# NEW YORK STATE DEPARTMENT OF ENVIRONMENTAL CONSERVATION

**Re: Hawkeye Trade Center and Residences, 1A, and 1B (C828203, C828207, and C828208)  
1405 and 1447 St. Paul Street, Rochester, Monroe County  
Revised Sub-Slab Depressurization System Design and Work Plan, November 2018**

# Sub-Slab Depressurization System Design and Work Plan

***Hawkeye Trade Center and Residences  
BCP Parcels 3, 1A and 1B  
1405 and 1447 St Paul Street  
Rochester, NY 14650  
NYSDEC SITES C828203, C82807 and C82808***

**FIGURE 2 - PROPOSED SSDS LAYOUT**  
**WBS CAPITAL, INC. - HAWKEYE**  
**1405/1447 ST. PAUL STREET**  
**ROCHESTER, NY 14650**

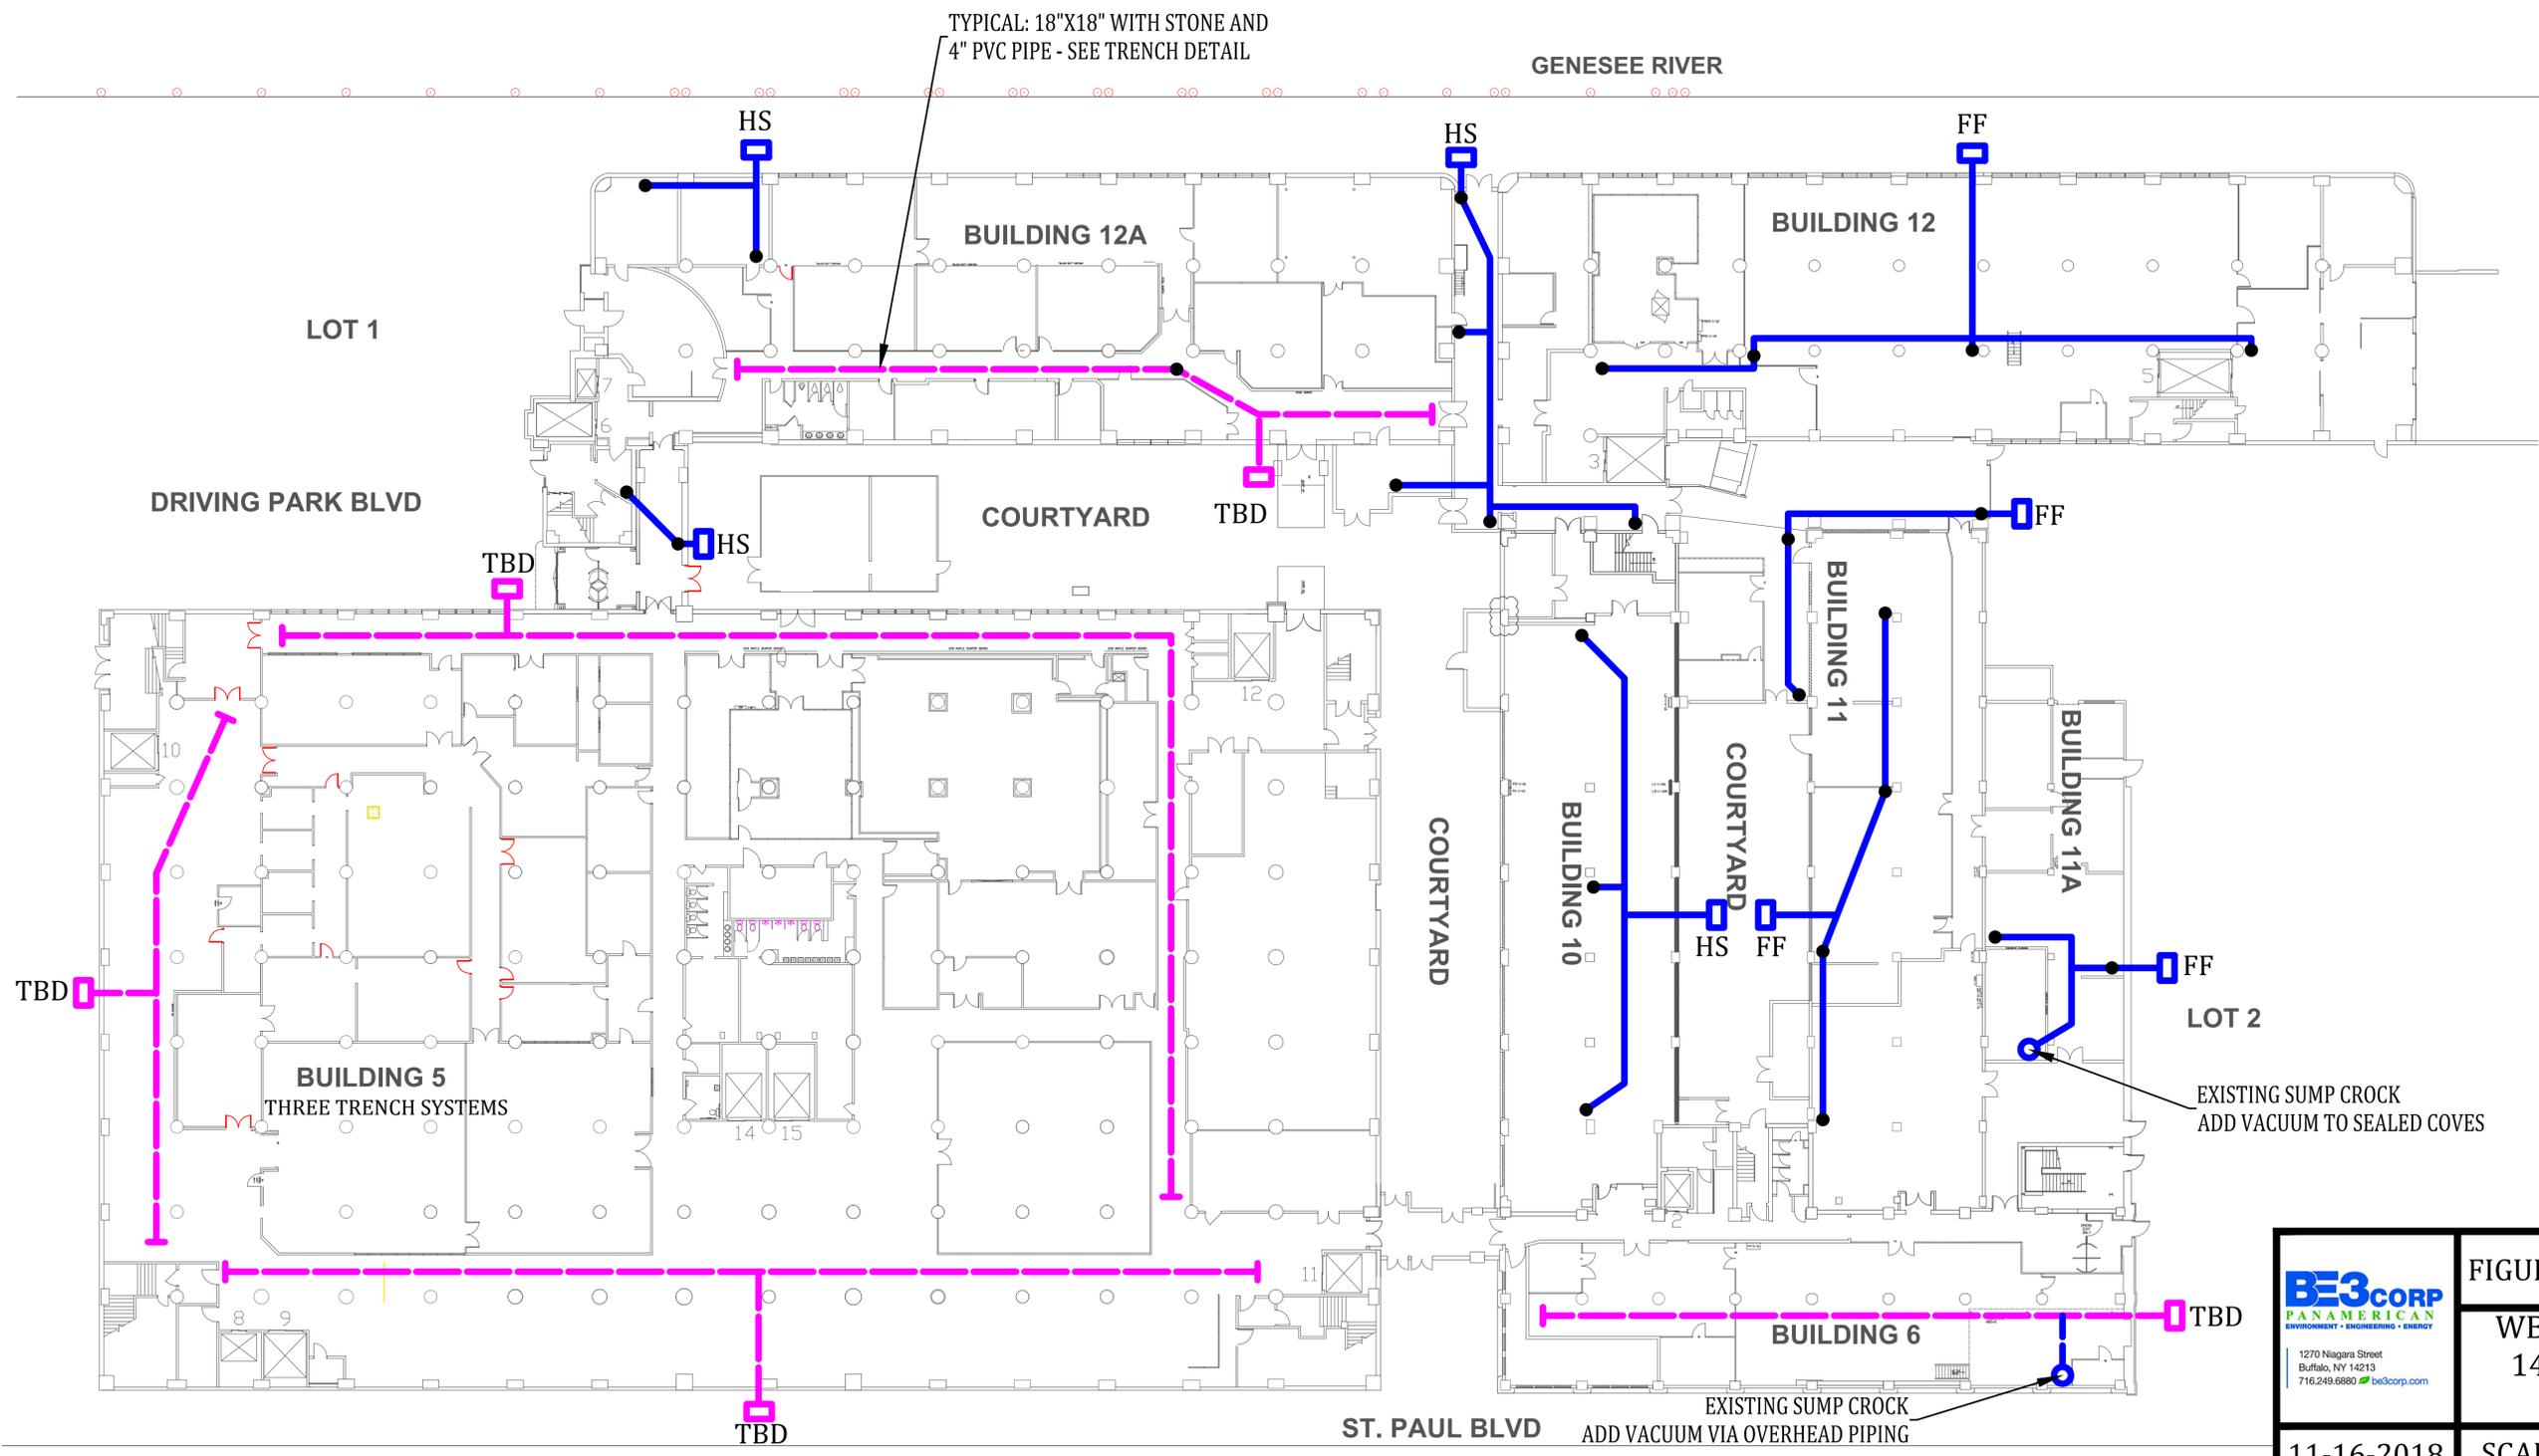
1. Based on Figure 2, it appears that the South side of Building 4 may not be mitigated during the IRM. Subsequent to installation of the sub-slab depressurization system, mitigation of the entire building will need to be verified and/or post-mitigation sub-slab soil vapor and indoor air sample results from outside of the pressure field will need to indicate there are no potential impacts or concerns to public health.

1270 Niagara Street Buffalo, NY 14213 716.249.6880   be3corp.com	FIGURE 4 - PROPOSED FINAL TEST POINTS	
	WBS CAPITAL, INC. - HAWKEYE 1405/1447 ST. PAUL STREET ROCHESTER, NY 14650	
11-20-2018	SCALE: 1" = 20'	SHEET 4 OF 6

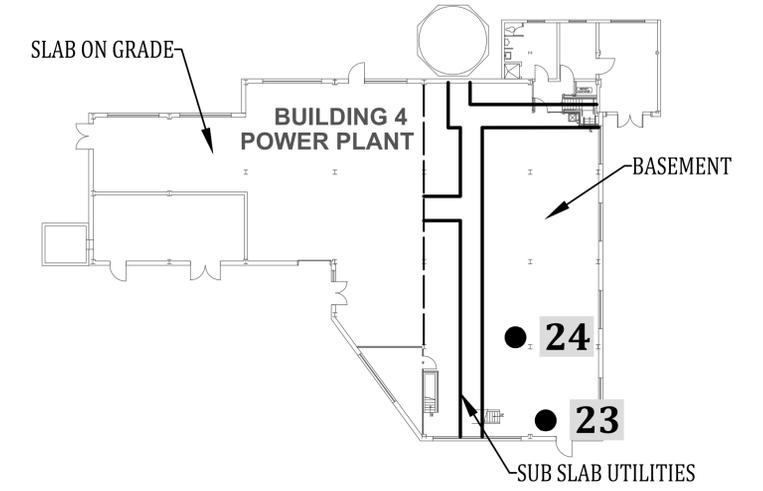
2. Related to Comment #1, although the communication test indicates some areas that may not receive adequate vacuum, the suction and test point locations as shown on Figure 4 are acceptable for the initial evaluation. However, additional test point locations may be needed during system startup to demonstrate adequate vacuum is achieved under the entire building and if adequate vacuum is not achieved, additional work will be required.

4. Figure 4: To clarify, test points 23 and 24 are mislabeled and are existing test points from the investigations.
5. Section 3.1: It is the Departments' understanding that there will be 10 suction points and 42 test points.
